GROUP	MODEL
Safety Recall Campaign	2011-2013MY Soul (AM)
NUMBER	DATE
SC284AM	June 2024

HECU MULTI FUSE REPLACEMENT (SC284AM)

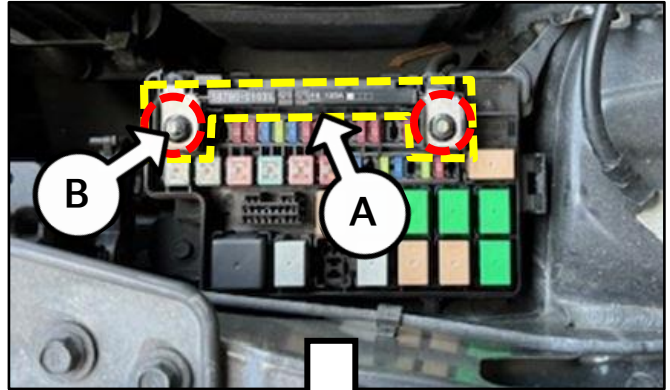
- 4a. Locate the Multi Fuse (A) for ABS1 and ABS2 loosen the two (2) 10mm Multi Fuse retaining nuts (B) and remove the Multi Fuse.

- 4b. Install the **new** Multi Fuse (A) and tighten the retaining nuts (B).

Tightening torque for retaining nuts (B):
7.2 - 8.7 lb.ft (9.8 - 11.8 N.m)

Note: Drill a hole through the center of the removed Multi Fuse. DO NOT reuse.

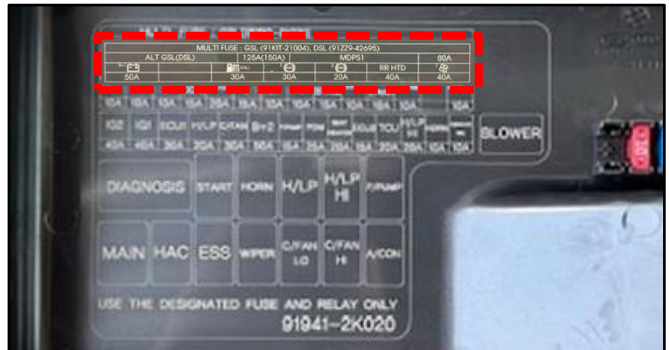
5. Adhere the new fuse label to the bottom of the junction box fuse cover, as shown.
